**SECTION 00 91 08**

**ADDENDUM NO. G8**

College of San Mateo  
North Gateway Project Part II

DSA Application 01-110307

LSK-2

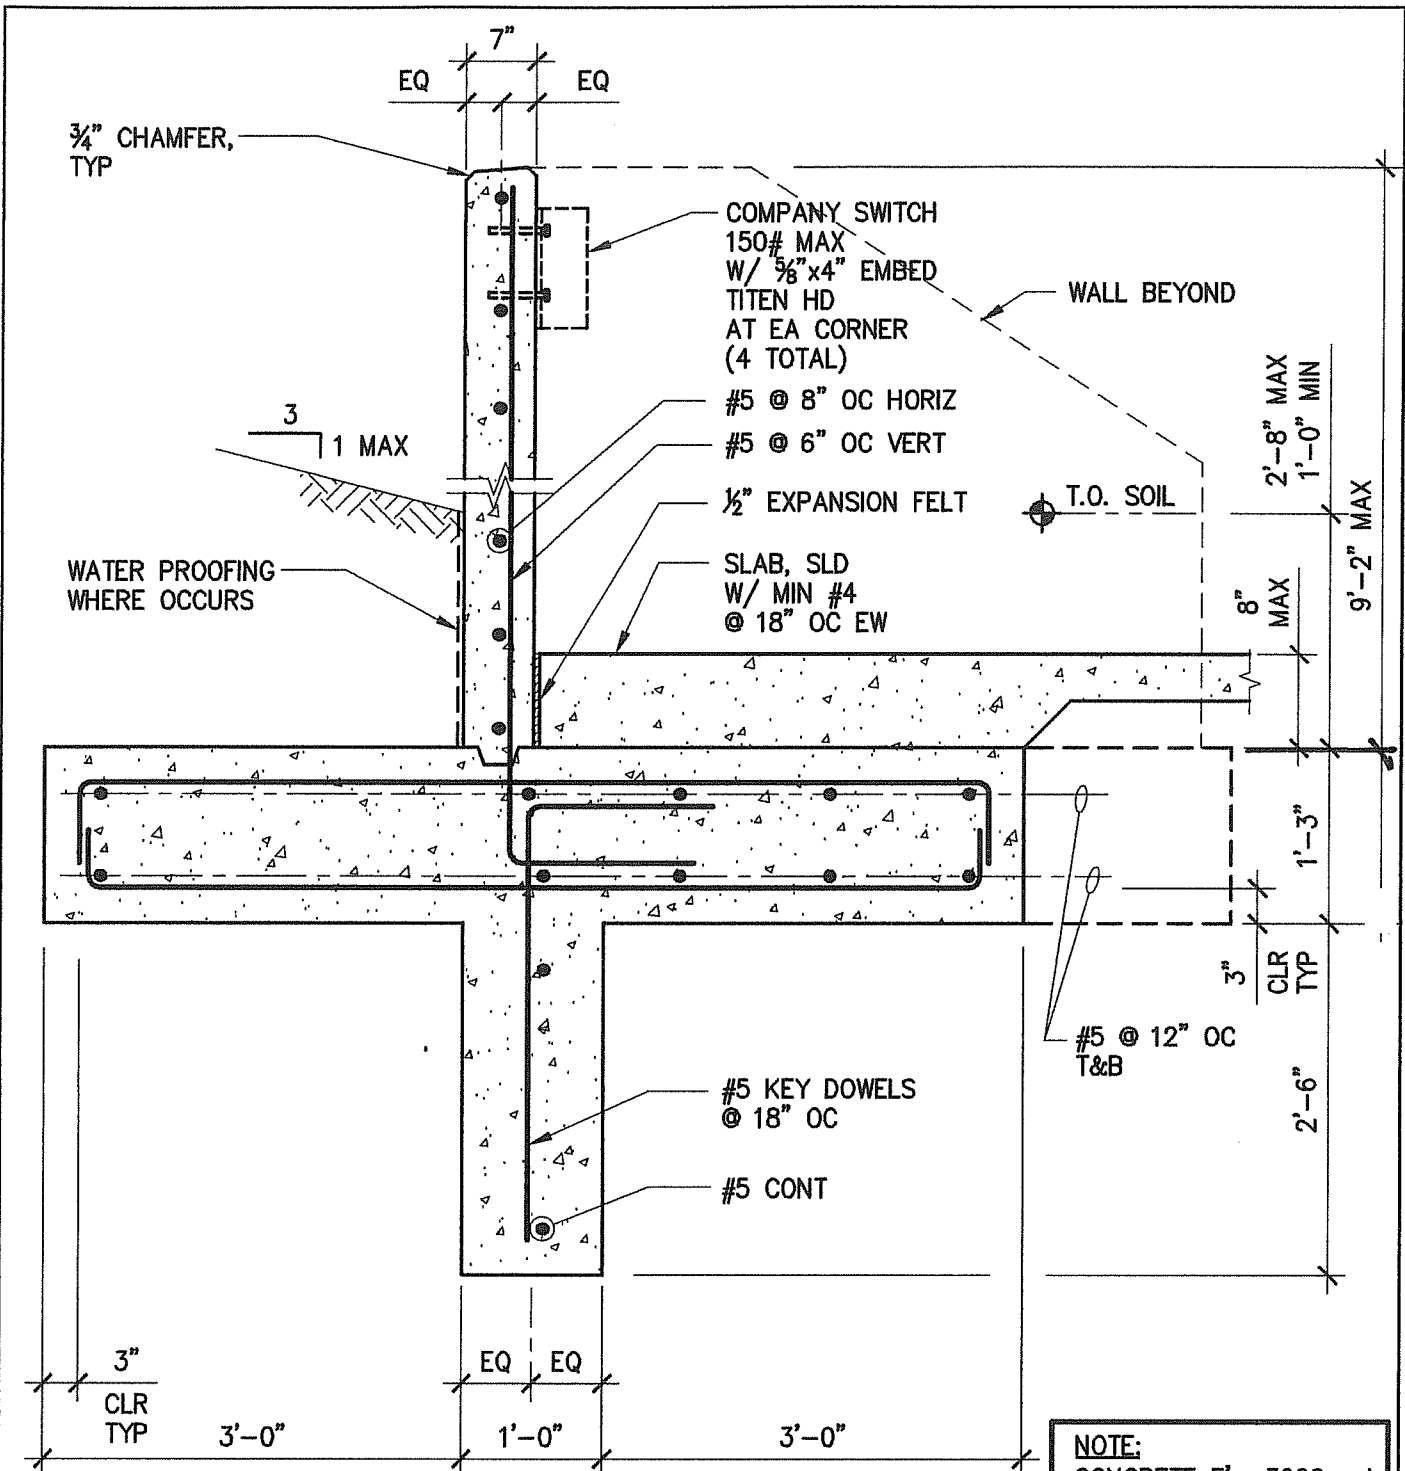
Item	Reference	Description
1.	L5.00	L5.00: Replace portion of Irrigation Legend per LSK-2, attached
2.	S1.01 DSA Application # 110308	Add detail shown on SSK-1 attached to Sheet S1.01 DSA Application # 110308
